WHITEMARSH TOWNSHIP PLANNING COMMISSION

MEETING OF AUGUST 11, 2020 6:00 PM

The agenda item is SLD #02-19, Preliminary Land Development Plans for Argos Associates/Adelphi Land Associates/Polergodom Group, Ltd. for 'Longfield Farm', for development of 58 townhomes on the site, within the VC-4, Village Commercial District, Sub-district 4. You will also recall that in addition to the 58 townhomes, there is an existing pre-1940's single-family home, fronting on Butler Pike, which is being preserved as part of the development. The approximate 15-acre site is located adjacent to the intersection of Butler and Skippack Pikes. This is a continuation of the Planning Commission's review of this project; it was last in front of the Commission on June 23rd, at which time there were a number of issues the applicant was asked to address. You will recall that a conditional use for the townhomes was approved by the Board of Supervisors on November 21, 2019 with eleven conditions. [The Conditional Use Decision was one of the items in the June 23rd meeting packet and is again included for reference. Other material from that packet is not included for this meeting but is still available on the websi

Longfield Landscape Plans

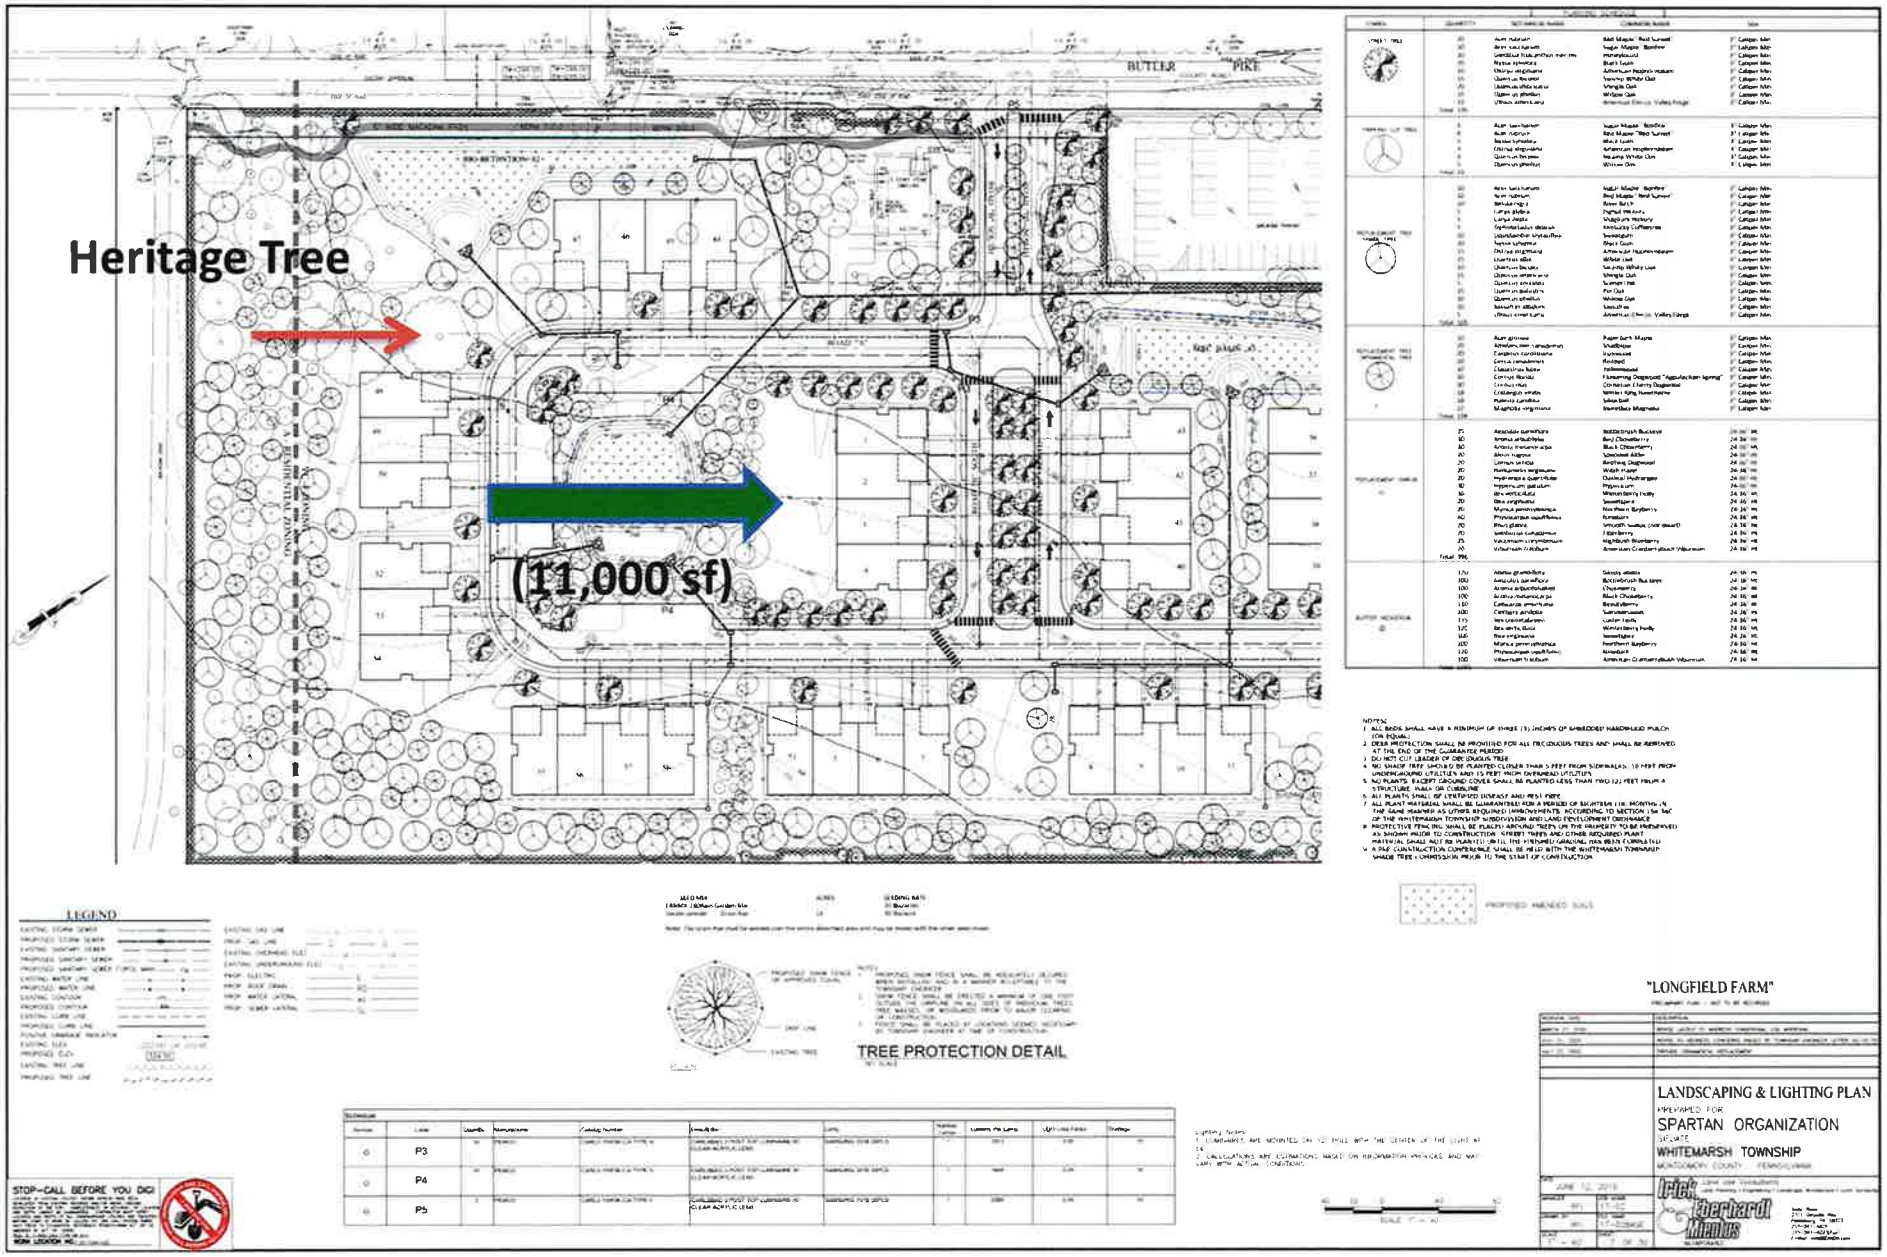
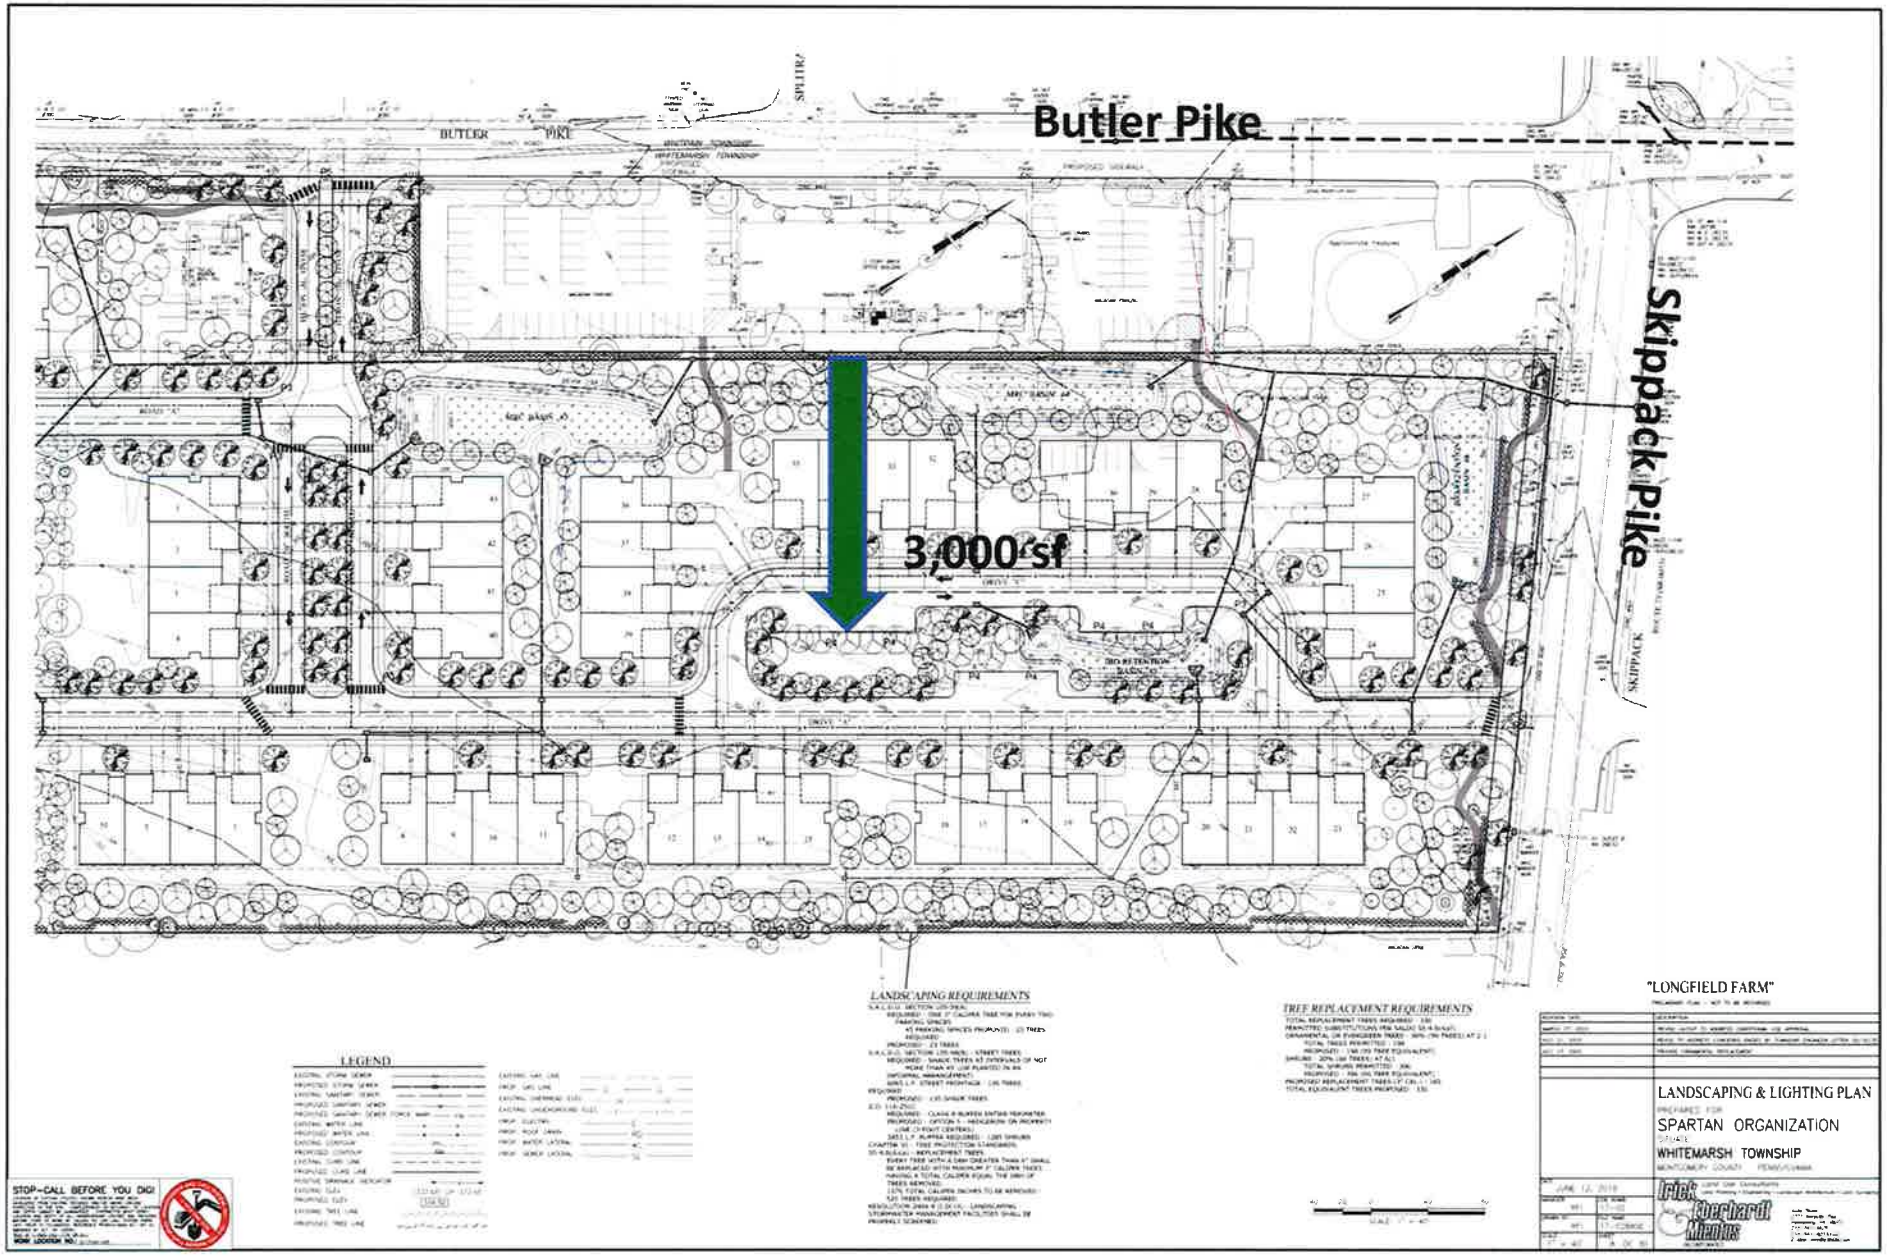
- **Item # 5 (Resolved) – Borough response – no intention to construct & do not recommended along either frontage citing major constraints**
- **Item # 6 (Resolved) – new Landscape Plan prepared & submitted; Twp. arborist's supportive review & STC approval with 1 acceptable condition at 8/4 meeting**

- **New Landscape Plan**
  - Focused on code compliance with diverse & high quality habitat, aesthetic value, seasonal interest
  - Appropriate horticulture, layered, & predominantly native species
  - Code compliant for street trees, parking lot trees, Class B buffer
  - Tree replacement accomplished on site - 330 trees tree equivalents with 20 additional shade trees per STC meeting approval (8/4)

LANDSCAPING & LIGHTING PLAN

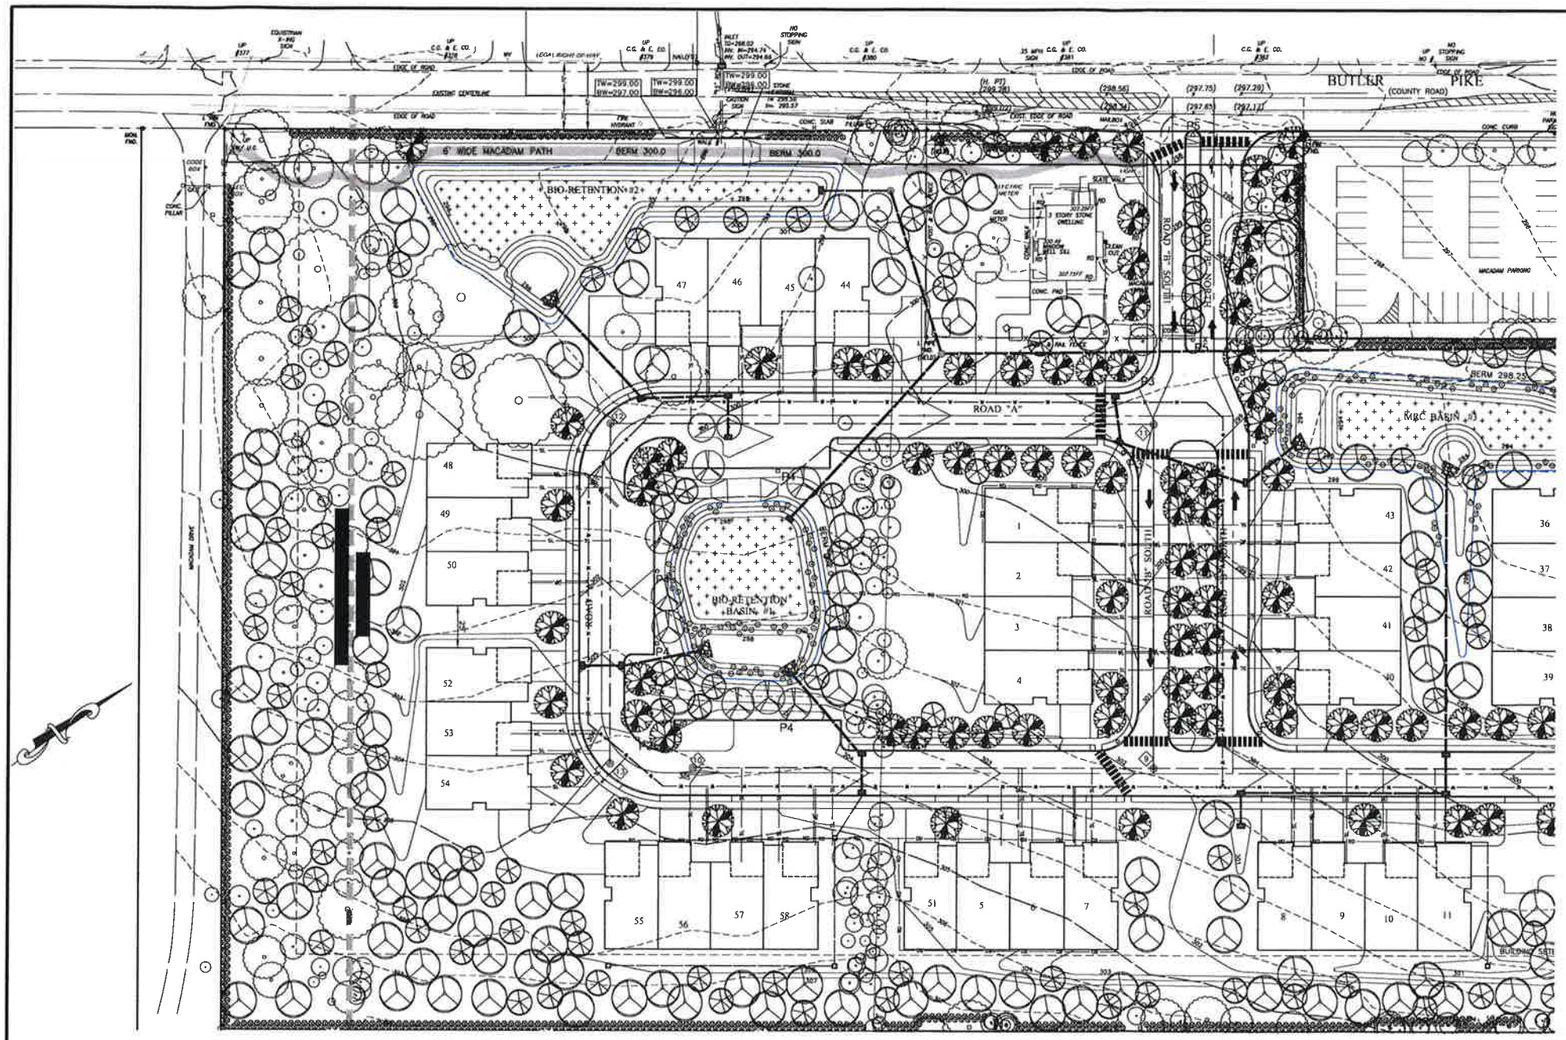
The second part included with this submission is a revised Landscape Plan (Sheet 7 and 8 of 30, revised 7/23/20) with updated numbers on all of the required landscape components – street trees per SALDO Section 105-48(B), parking lot trees per SALDO Section 105-39(A), basin landscaping, and tree replacement per Chapter 55. Buffers (Class B, Option 5) per Zoning Section 116-291C are provided to the extent required. The code requirements for all landscape categories are met, including the full complement of replacement trees. Further, the replacement trees utilize the provisions of allowing understory trees, shrubs and perennials at the approved ratios per the SALDO.
